Improvement of Drinking Water and Sanitation Systems in Mombasa, Lot 1 - Construction of the Mwache Trunk Main (Section 1), South Mainland Transmission Main and Dongo Kundu Reservoir (CWWDA/AFD/W4/2022-2023)

REQUESTS FOR CLARIFICATIONS BY BIDDERS AND RESPONSES – set 02		
S/No.	Request for Clarification / Query	Response
1	BILL1-A290.2 BILL1-A290.2 Pipeline Routes quantity 35km, but LOT1 all routes quantity is 48.7km, and engineers need to clarify the actual amount of work. Remark: Allow for Establishment of Level Datum, Topographical Survey, preparation of an updated Layout Plans with Contours at 1m interval, submission of Survey Drawings to the Resident Engineer and Setting Out of proposed Structures and Pipelines.-Pipeline Routes	It is not clear how the bidder has arrived at a total length of 48.7km for the Lot 1 pipelines.Total length of proposed pipelines under the current project is 32.2km. The 35km allowed for in the Bill Item is to take care of any additional topo survey works that may arise. (Refer to Bill No. 2.2 Item I45; total length 3.08km and Bill No. 3.2 Item I45; Total length 29.15km).

Drawing No. M430-SD-10 – Pipe Trench & Concrete Surround

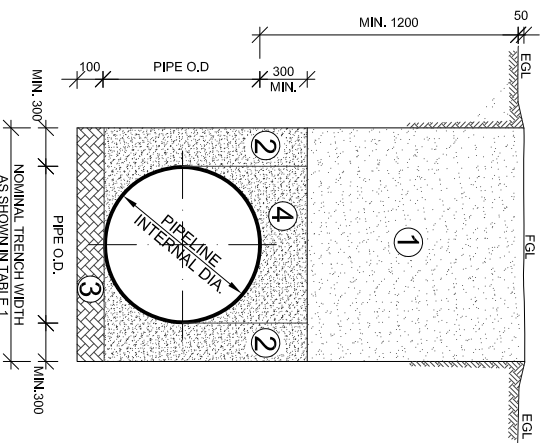
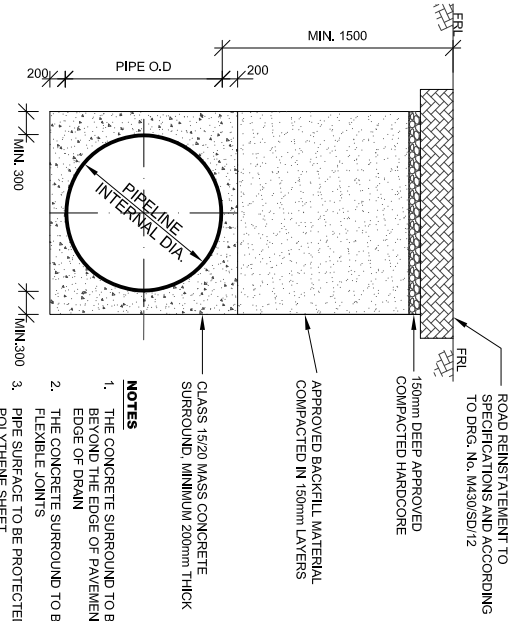
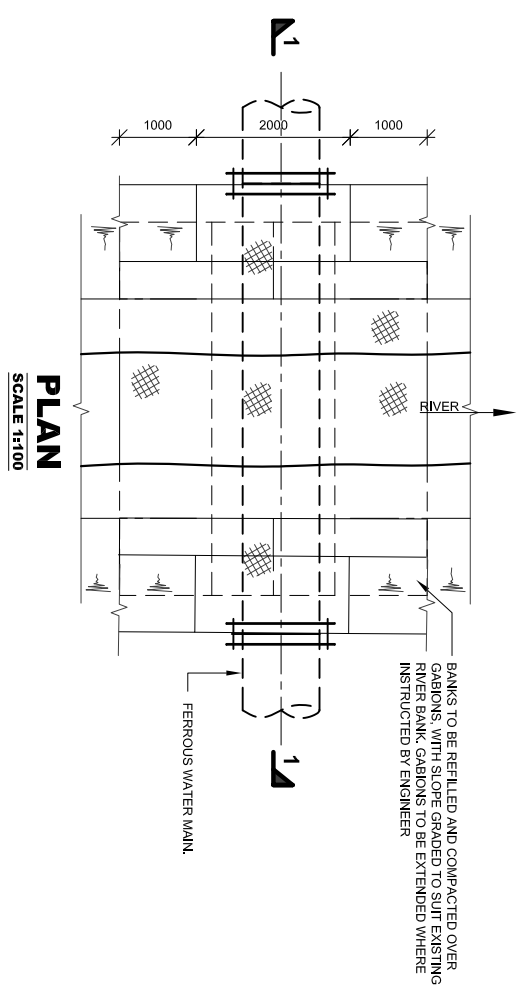
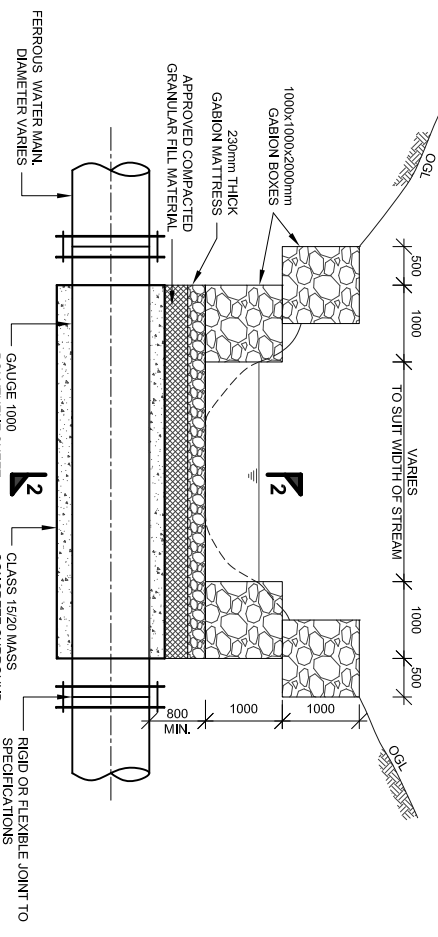
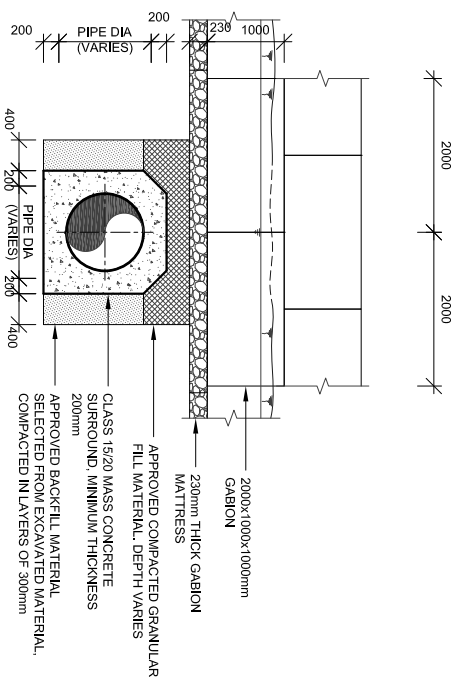
REQUESTS FOR CLARIFICATIONS BY BIDDERS AND RESPONSES – set 02		
S/No.	Request for Clarification / Query	Response
30	<p>Surrounds We noticed that the total quantity of surrounds, expressed in meters, are twice the length of the pipeline in BILL No. 2.2 - TWIN TRUNK MAIN SECTION 1 (LINE TM1), as shown hereafter. Could you clarify?</p>	<p>Correct the typo on quantities as follows: Bill 2.2 Page 14 of 20; Item L525 – Revised Quantity 1850, Item L535 – Revised Quantity 1230 The corrected BoQ page is attached herewith</p>
31	<p>Piling Works for Mwache Creek Crossing Item X992.6.1 description indicates that the Contractor shall 'provide all materials and install cylindrical driven and cast-in-situ friction piles, diameter 150mm; to receive pier bases, minimum depth of pile 120m, all as directed by the Structural Engineer on site. Rate to include for provision and placing of vibrated class 25/20 Reinforced Concrete internally in the steel piles, etc. all as directed. Minimum No. of piles per pier is 4Nr'. Could you clarify the following :</p> <ul style="list-style-type: none"> ● Depth of pile, as 120m per pile look outrageously oversized ● Number of piers, as 250 piles are deemed necessary, we conclude that 62 piers shall be installed (4 piles per pier), with a center to center distance of 15m (type 1, as indicated on longitudinal profile). It results a crossing length of approximately 900m, which is twice the Mwache crossing length. Could you clarify the scope of Works and quantities to be considered? 	<p>120m is a typo. Corrected to ranging from 12m to 20m See updated BoQ Items in the re-issued BoQs for piling works at the Mwache Creek Crossing. Note: find attached an updated version of Bill No. 3.2 with the items for Mwache Creek Crossing revised. A new Item X992.6.1 has been inserted (design of piling works) and Item X992.6.2 (previously X992.6.1) with revised item description for the Bill Item. Note: an additional provisional sum has been added to Bill 3.2 Item X997 to allow for rehabilitation of existing pipeline over the bridge at Mwache creek.</p>

- Updated Specification
- Updated BOQ (PDF format)
- Drawing No. M430-SD-10 – Pipe Trench & Concrete Surround
- Lot 1 Bidding Doc. Vol1 - Appendix 2
